L42-1 Task force teleconference meeting 4-11-2006

Dana model 44 2006 axle build

To: Cory Koglin
From: Kenny Miller
Date: April 7, 2006
Subject: Problems / progress with current L-42 order.

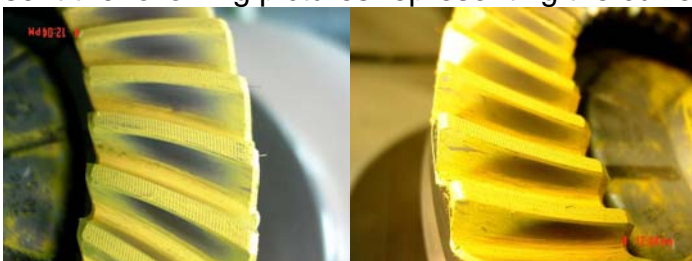
I went to the Lugoff plant last Monday, April 3rd to work with Derek Ottley and the Lugoff assembly team to build the L-42 axle hardware. Through the course of the day, we built 9 diff carrier assemblies. From the start we had an issue of the drive-side contact pattern too near to the toe, i.e. L1 to L0.5. While L1 may have been a deviation-allowed contact pattern, L0.5 was not. The majority of the 9 carriers were the latter. Please see the following pictures:

Picture 2 and 4 above represent the range of drive side variance (includes assy variance for trying to correct the DS toe pattern).

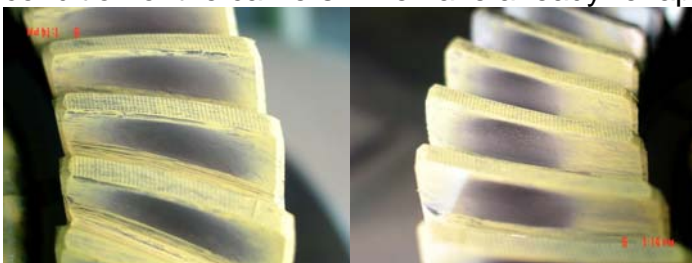
We contacted Lou Pappademos (Quality Mngr, Bevel Gr Products) at Fort Wayne to determine the current lot 'as-manufactured' Gleason test machine contact pattern for the L-42 gearset. Lou sent the following pictures representing the current run of 044GA103X:

The contact pattern development exhibits exactly the desired goals, drive side L2F0 and coast side L3F+1.

044GA103X, 4.09 LH (11 x 45) (Axle assy 044AA100-1) ASTM 4/11/2006

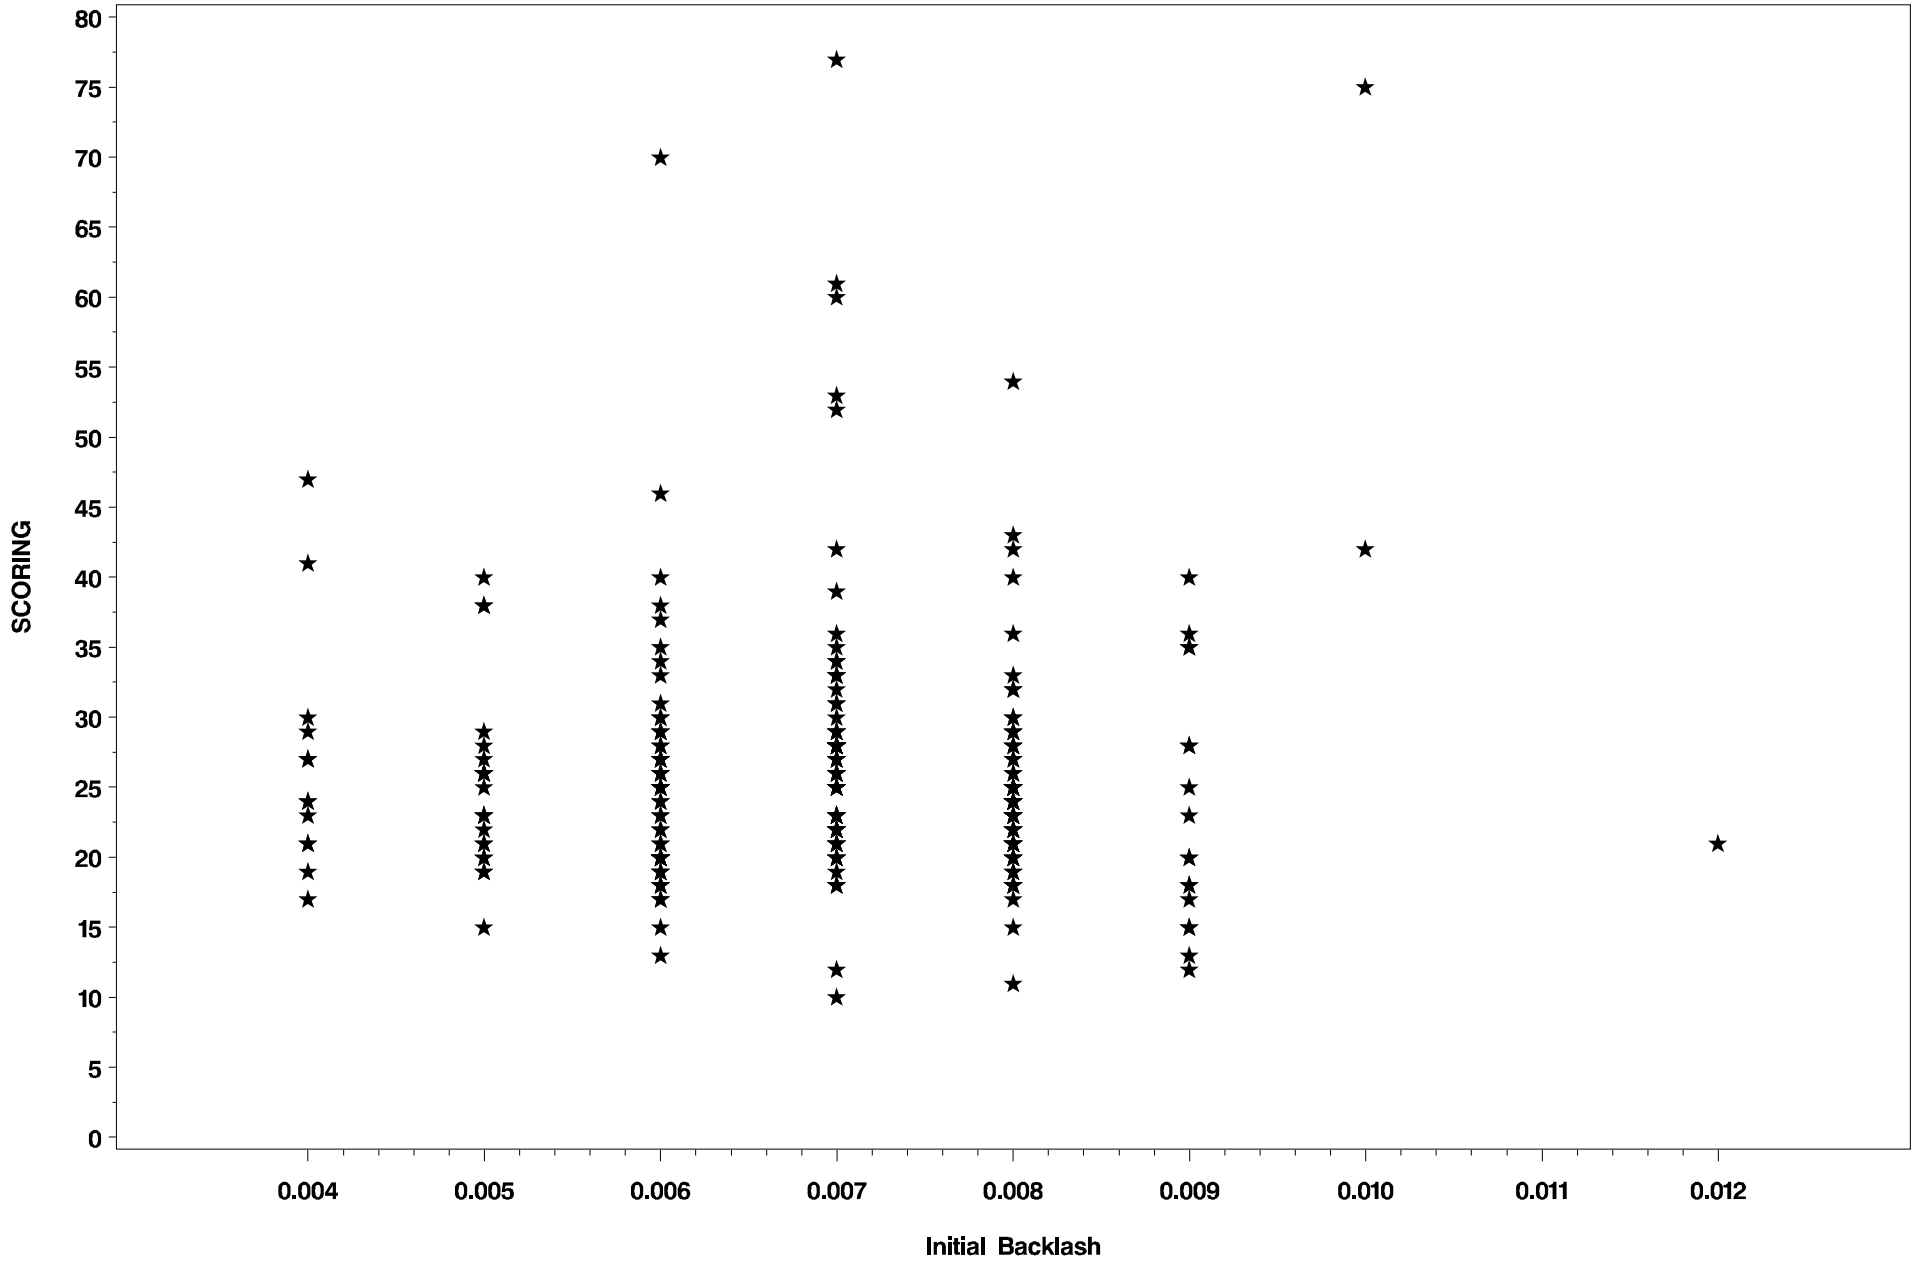
This report represents sampling from (10 qty) diff builds of re-lapped (drive side only) gearsets. Re-lap was done to correct too much toe-ward contact pattern position on the drive side. 5 gearsets were recorded and represent the total build variance of all 10 sets.

Note: Backlash is more than specified maximum of .009". This is necessary to control the coast side -F- number.
